## SUBDIVISION REVIEW SHEET

**CASE NO.:** C8-2022-0112.0A

**SUBDIVISION NAME:** Velocity Phase 2

**Exhibit C: Comment Report**  
**CITY OF AUSTIN –DEVELOPMENT SERVICES DEPARTMENT**  
**SUBDIVISION APPLICATION – MASTER COMMENT REPORT**

## Exhibit A: Vicinity Map

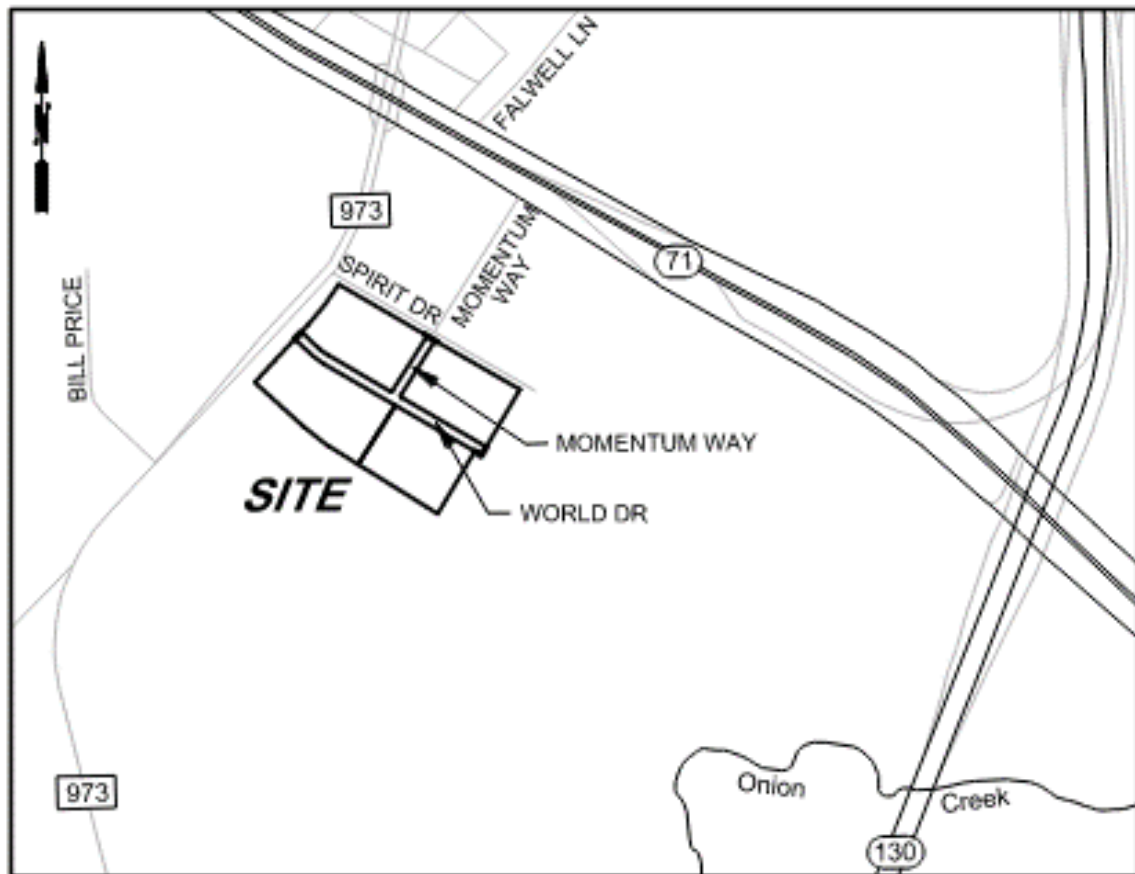
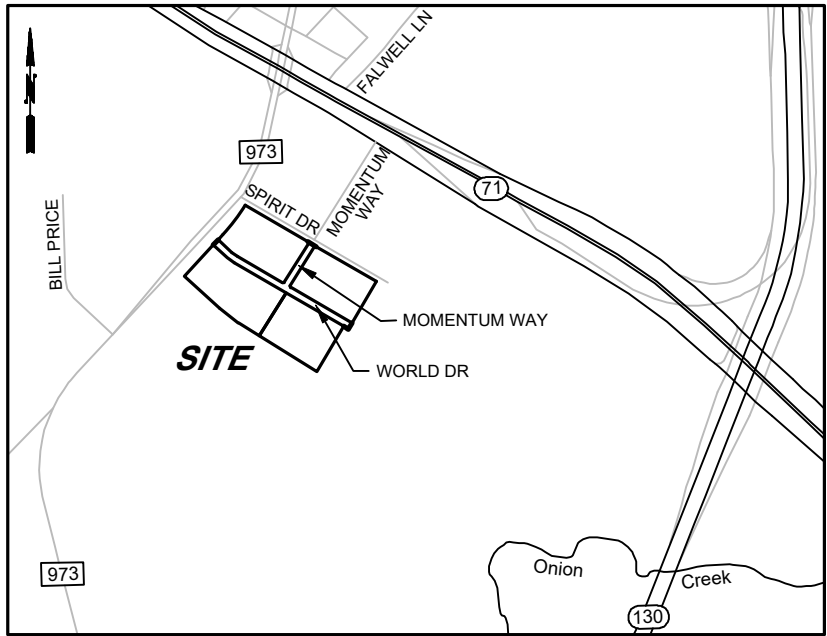
- AD1.** Please update label for **S FM 973 RD** the directional S and street type RD must be included in the exhibit and the vicinity map §25-4-155

**SR3.** Please place the vicinity map on sheet 1 (25-1-83)
